PLANNING AND ZONING COMMISSION MEETING AGENDA

February 07, 2024 at 7:00 PM

Town Hall - 1941 E. Jeter Road, Bartonville, TX 76226

1. Discuss and make a recommendation regarding a Preliminary Plat for a 101.467-acre property situated in the Daniel Cook Survey, Abstract Number 230, and A.M. Feltus Survey, Abstract Number 1594, in the Town of Bartonville, Denton County, Texas. The property is located on the north side of E Jeter Road, approximately 2,185 feet east of the intersection of E Jeter Road and Country Court, in Bartonville, Texas. The applicant is Mycoskie & Associates, Inc., on behalf of Knight's Landing West. [Town of Bartonville PP-2023-004.]

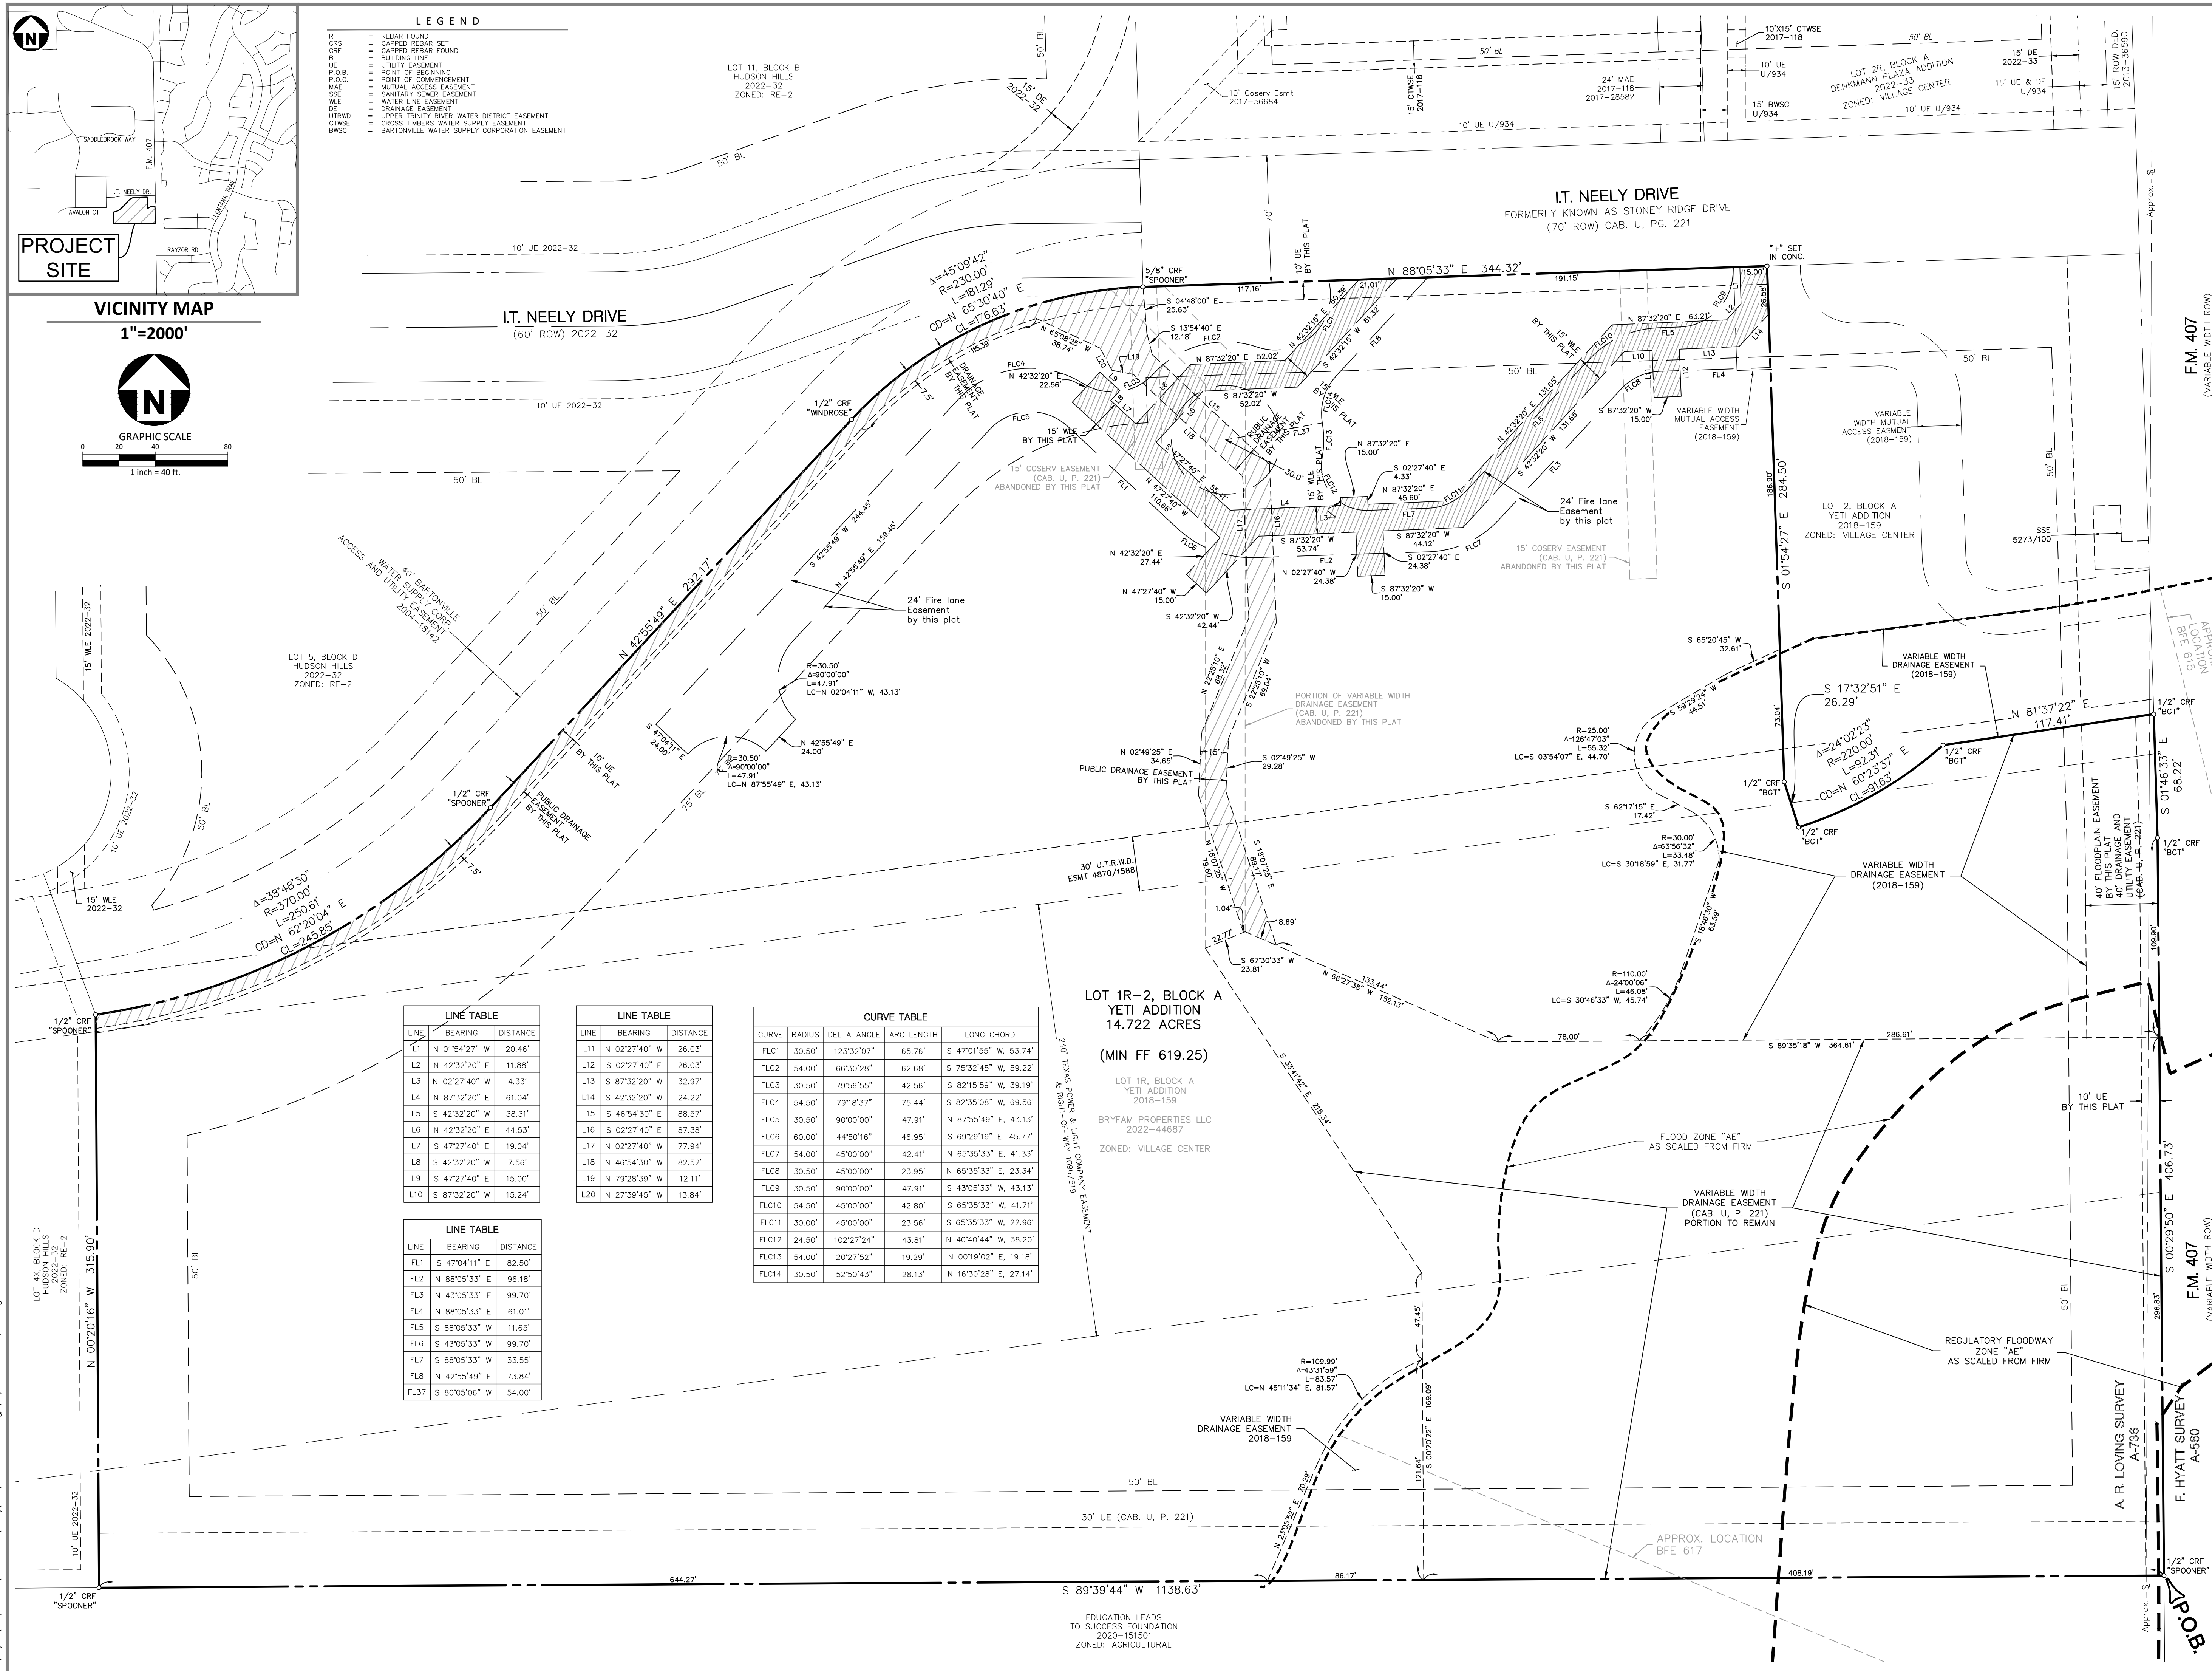
The plat conforms to the Village Center (VC) zoning district requirements, with the exception of a missing 20-foot building setback along the shared property line with Lot 2, Block A. A condition of approval shall require that the 20-foot setback be added prior to recordation. The plat establishes a 50-foot building setback line, with the exception of a 75-foot setback adjacent to Lot 5, Block D, Hudson Hills. This meets or exceeds the VC setback standards. However, Bartonville Zoning Ordinance (BZO) Section 12.3.B.1. establishes a special side and rear setback standard for buildings greater than 15 feet in height. Though the proposed buildings on the lot exceed this maximum height, the site plan review will establish the evaluation and regulation of the building setbacks, and do not affect the building lines established on the plat.

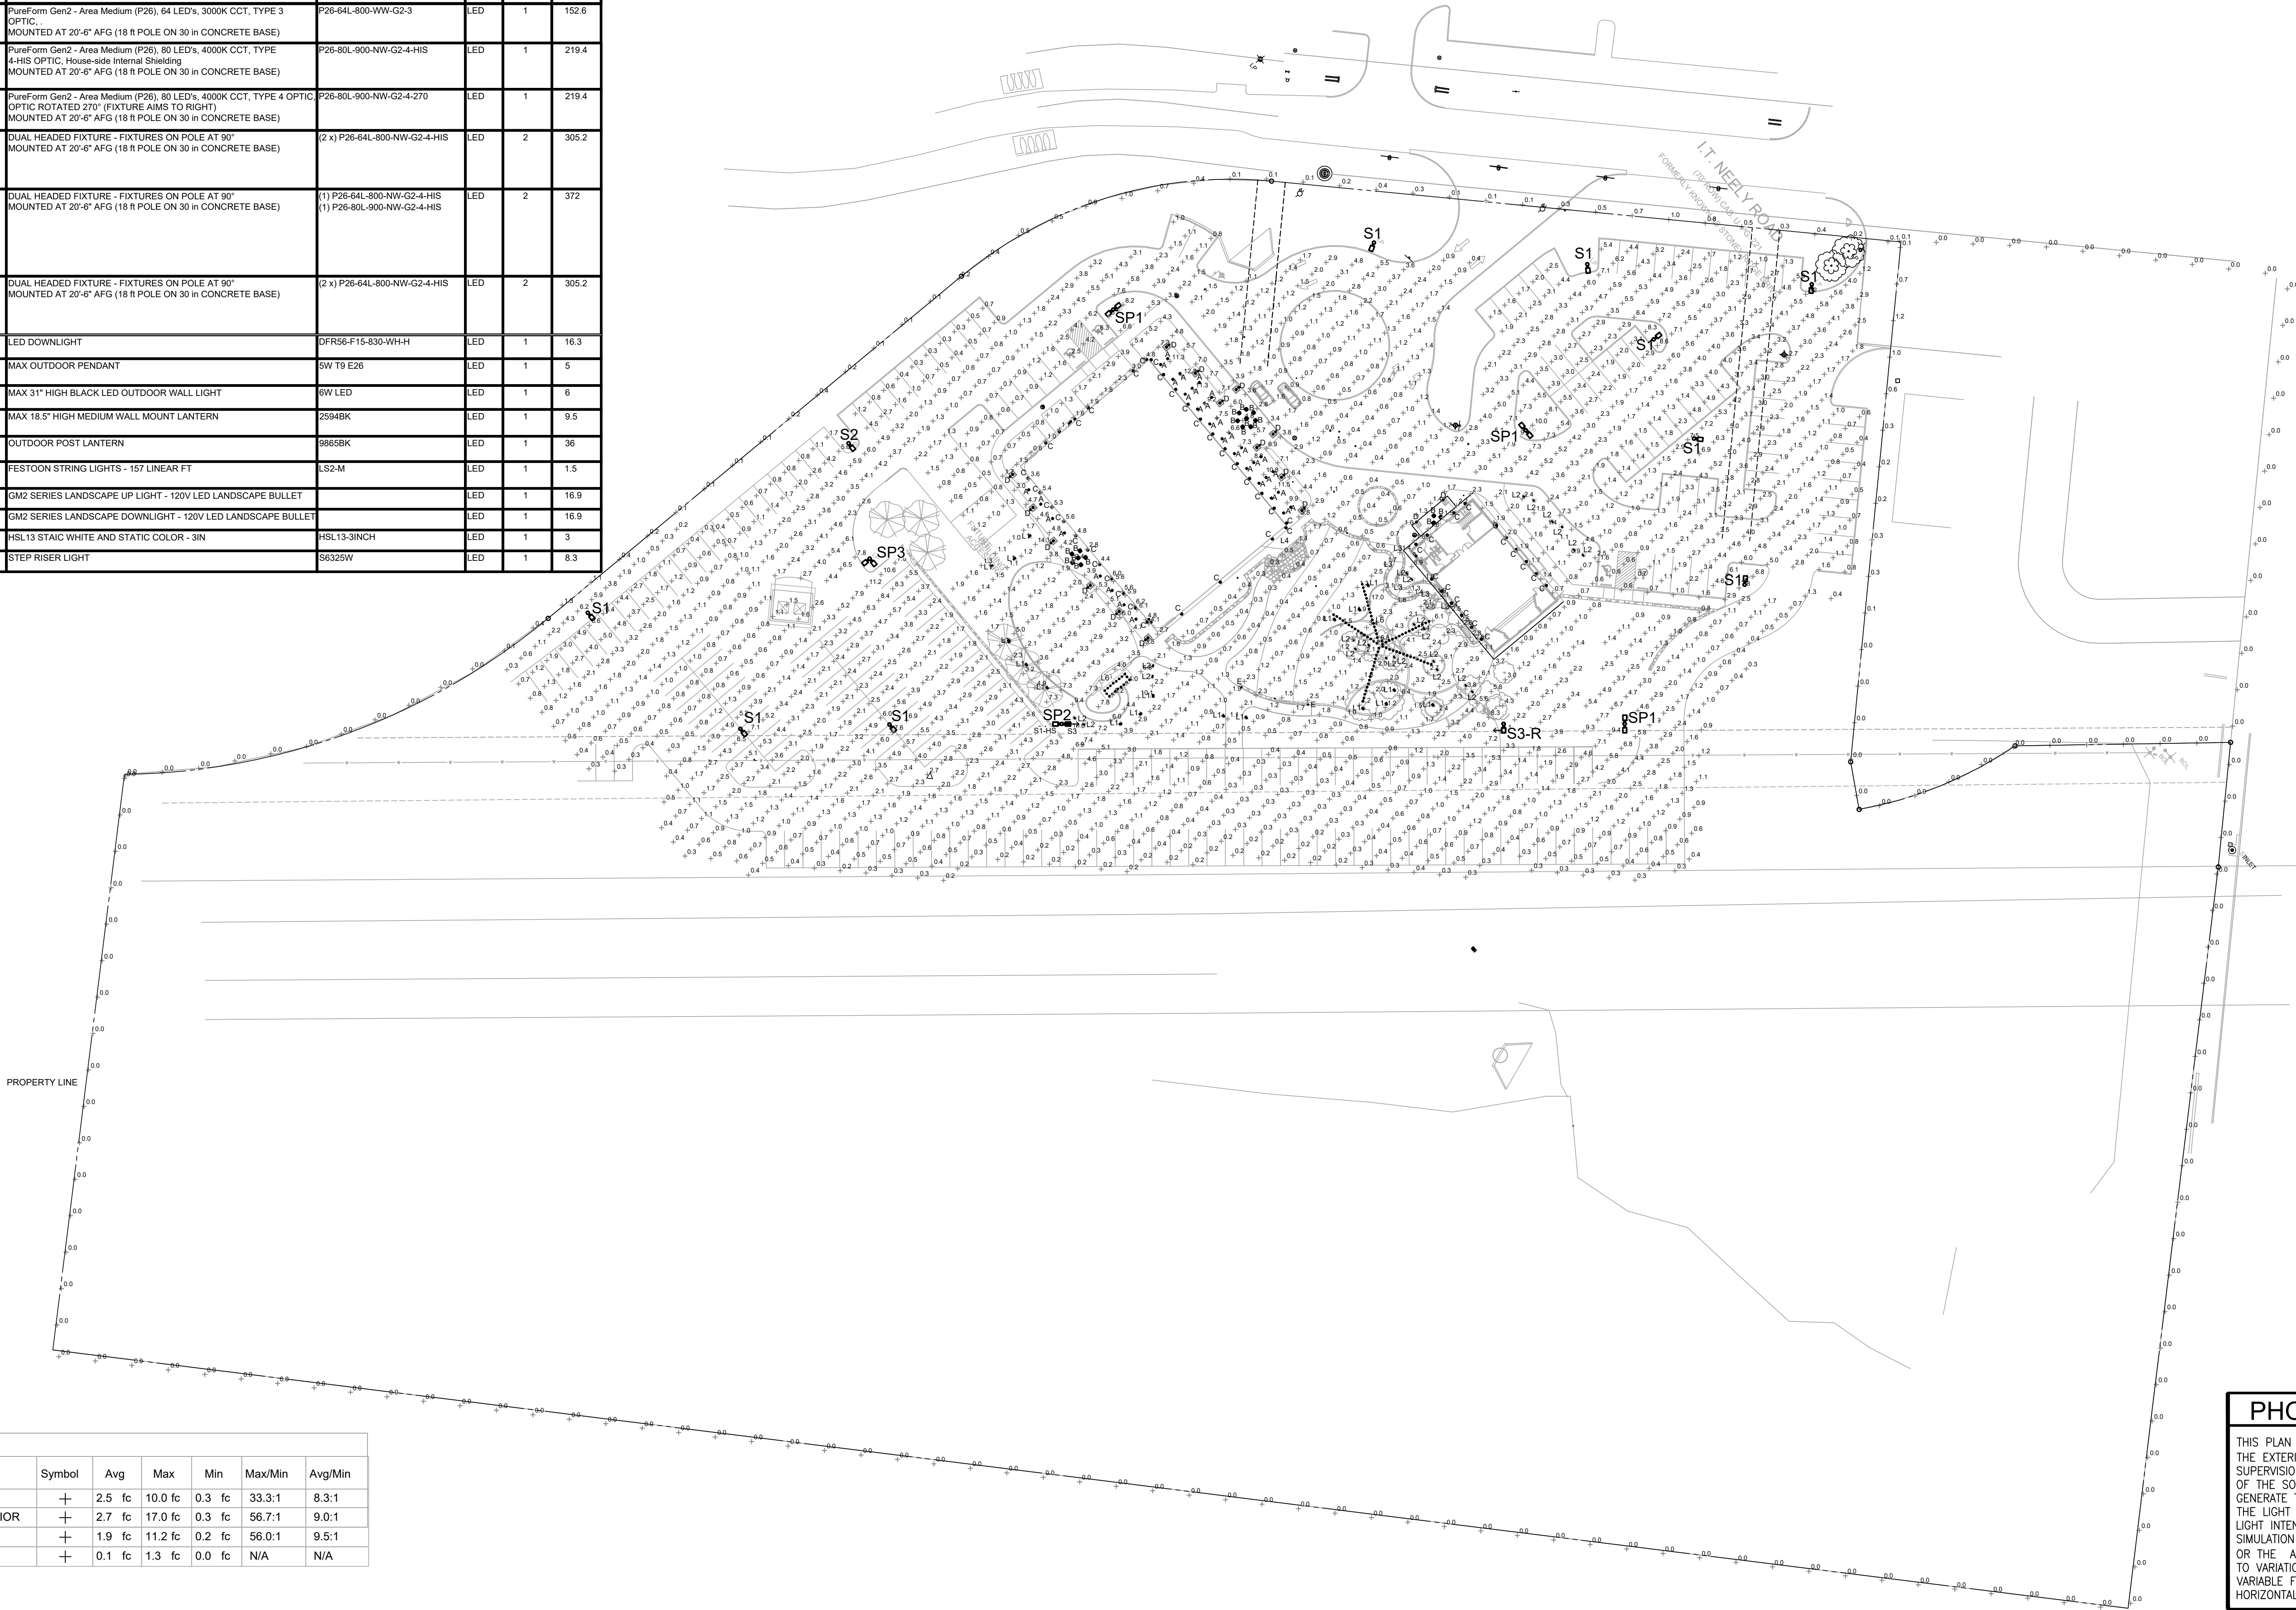
Site lighting is provided in a photometric plan. While the illumination standards for the site are generally met, the location of the light pole and the light intensity along the site's northwestern boundary, which is shared with Lot 5, Block D, Hudson Hills exceeds the standards listed in BZO Section 28.2. Proposed conditions of approval have been identified to mitigate these impacts.

- i. In accordance with BZO Section 12.3.5.5., lights shall be fully shielded to minimize light trespass onto any residential zoning district. "Fully shielded" means a technique or method of construction or manufacture that does not allow any light dispersion to shine above the horizontal plane from the lowest light-emitting point of the light fixture. Any structural part of the light fixture providing this shielding shall be permanently affixed to the light fixture.
